# CITY OF ALBUQUERQUE

**RE: Juan Tabo Hills Estates  
Manhole 47  
Drainage Report Stamp Date: 5/10/18  
Revision Sheet Stamp Date: 5/23/18  
Hydrology File- M21D018; DRB# 1005278**

Based on the information provided in your submittal received 5/23/18, this submittal cannot be approved for Work Order by Hydrology until the following are corrected.

CITY OF ALBUQUERQUE  
PUBLIC WORKS DEPARTMENT  
TITLE: JUAN TABO HILLS ESTATES  
STORM SEWER TRUNK LINE  
CULVERT INTERNAL ENERGY DISSIPATORS

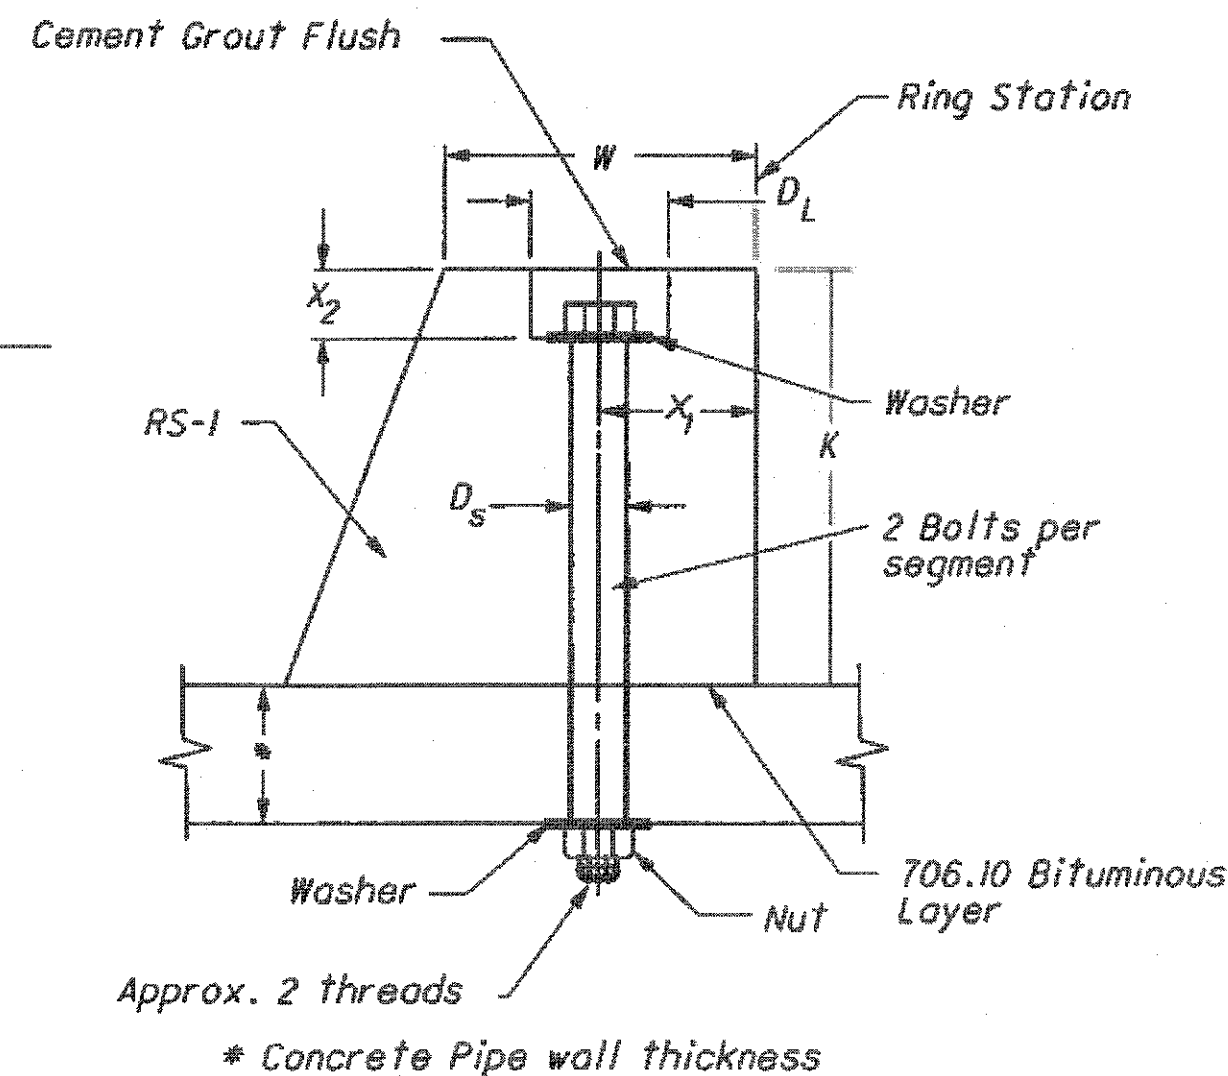
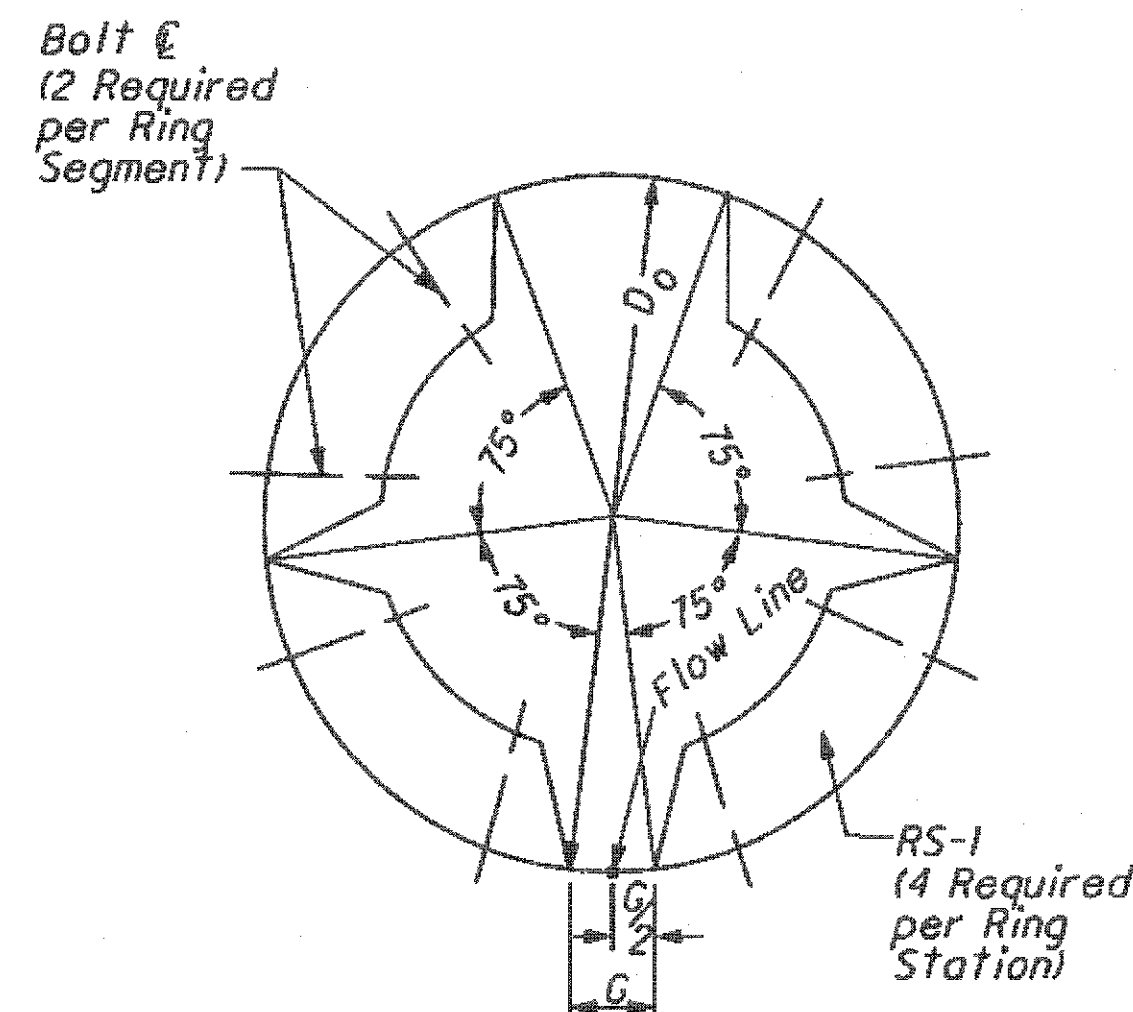
1. For RCP on steep slopes (greater than 20%), provide concrete pipe anchors, ~35' o.c. This must include a detail, complete with dimensional data, reinforcement if needed, and specifications. The CoA has no standard detail for this sort of thing, all build details will need to be provided by the Engineer.

TITLE: JUAN TABO HILLS ESTATES STORM SEWER TRUNK LINE UTILITY PLAN & PROFILE

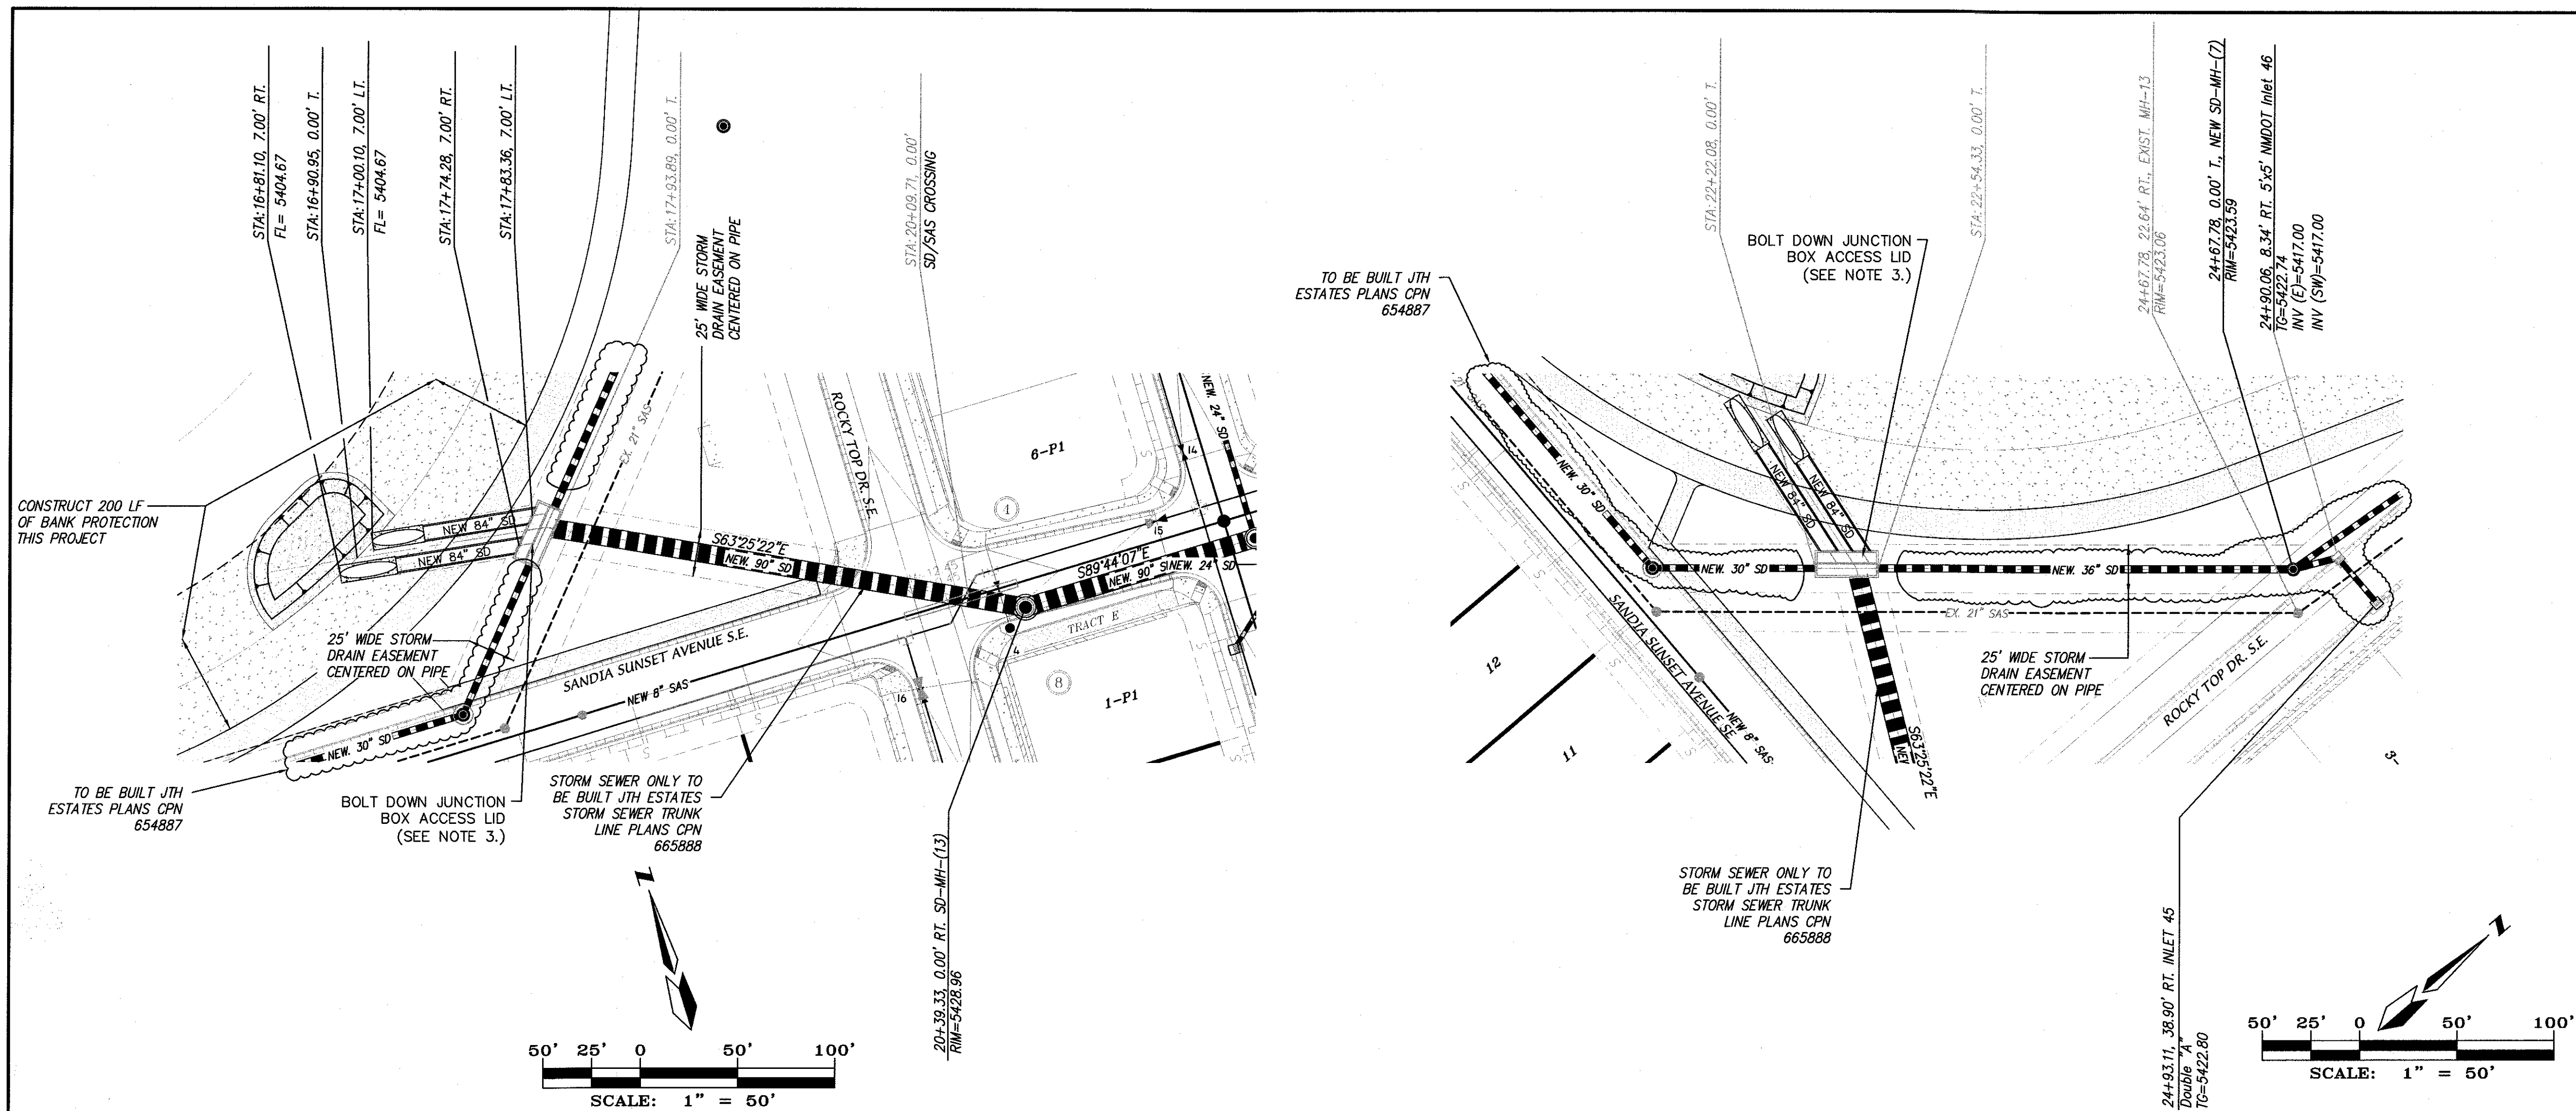
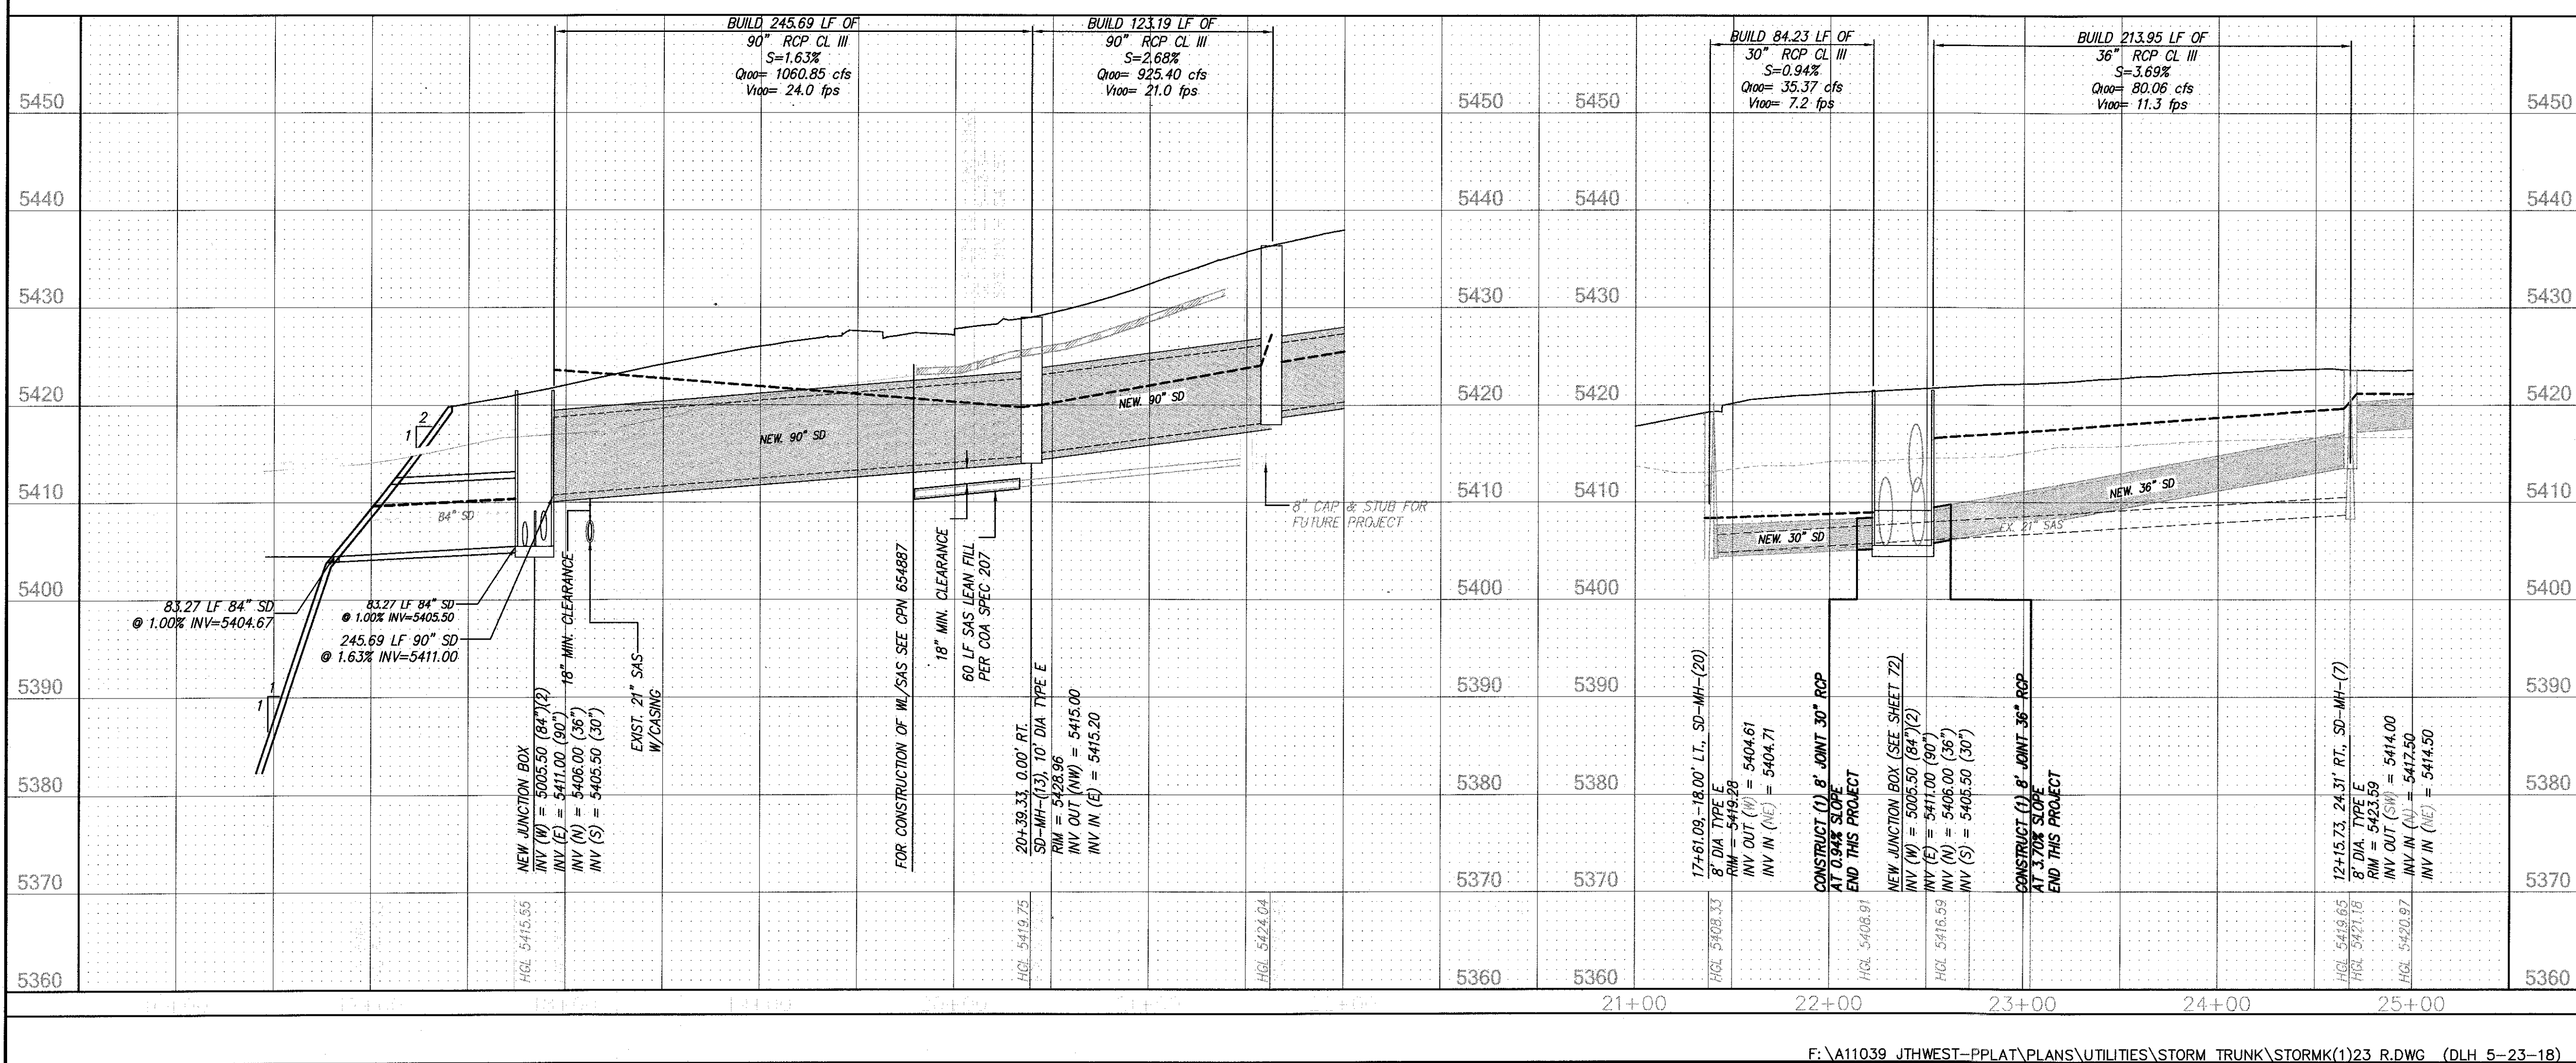
1. An addition has been added to note 5 on sheet 5 of 6 to bolt down the lid at MH-47.
2. An addition has been added to the notes on sheet 5 and 6 of 6 to bolt down the lid at the junction box between MH-13 and Tijeras.
3. Note 6 has been added on sheet 5 of 6 to provide concrete pipe anchors spaced 35' O.C.
4. MH-47 missing DIA and INV OUT has been corrected.
5. The slope between MH-47 and MH-9 has been corrected
6. Additional sheets 5.1 and 5.2 have been revised to show COA in title block and have been stamped and signed.

3. LID OPENING ON JUNCTION BOX SHALL BE BOLTED DOWN SAME AS IS DONE ON ALL THE STORM MANHOLE LIDS LOCATED IN SANDIA SUNSET AVENUE.
